## NINE MILE POINT NUCLEAR STATION

**SUBJECT:** Nine Mile Point Nuclear Station  
Unit No. 2; Docket No. 50-410

Response to Request for Additional Information Regarding Nine Mile Point Nuclear Station, Unit No. 2 – Re: The License Amendment Request for Extended Power Uprate Operation (TAC No. ME1476) – Containment Accident Pressure, Combustible Gas Control, Pipe Stress Analysis, and Boral Monitoring Program

Figure K-1. Extended Power Uprate Piping Evaluation

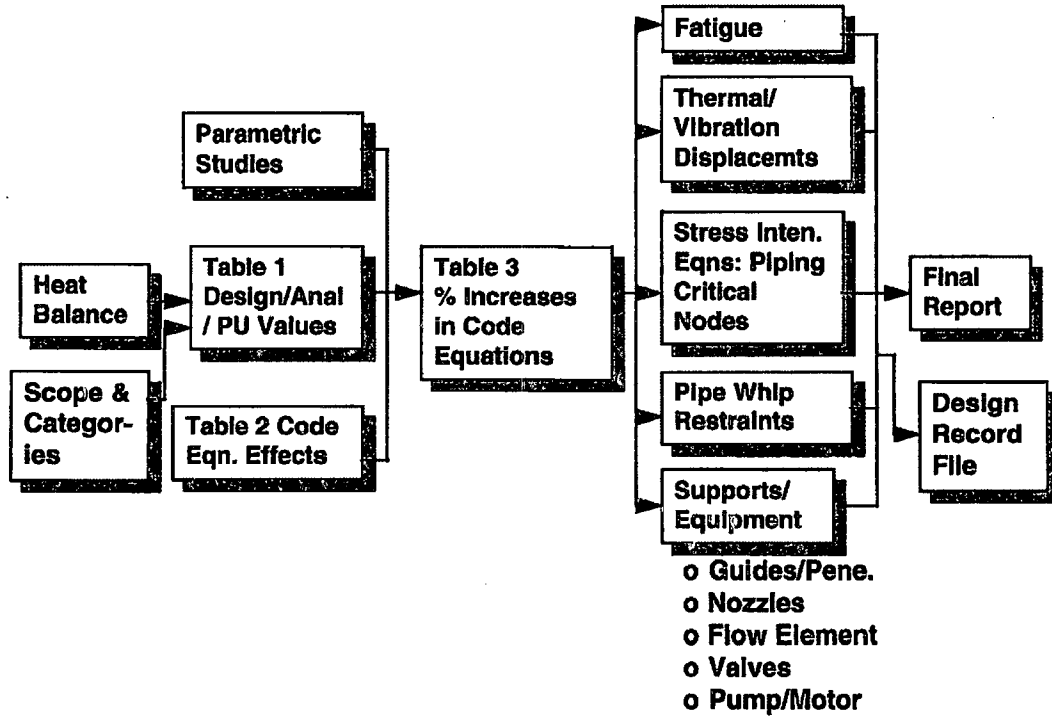
*Provide an example(s) to quantitatively demonstrate how the scaling factor of 5.1 in PUSAR tables 2.2-2a and 2.2-2b are derived.*

For the NMP2 EPU, the value of 5.1 in PUSAR Table 2.2-2a and b was determined by identifying the percentage change in steam flow and applying it to an enveloping curve (Figure 1) generated as a result of the parametric studies. This renders a stress increase of 5.1% for ASME equation 9B. In this case, the change in steam flow was calculated by using the following equation:

$$\text{Steam Flow at 102\% EPU} / \text{Steam Flow at 100\% CLTP} = 18.066 \text{ Mlb/hr} / 15.002 \text{ Mlb/hr} = 1.204 \text{ or a percentage change in steam flow of 20.4\%}$$

Steam Flow at 100% EPU / Steam Flow at 100% CLTP = 17.636 Mlb/hr / 15.002 Mlb/hr = 1.176 or a percentage change in steam flow of 17.6%
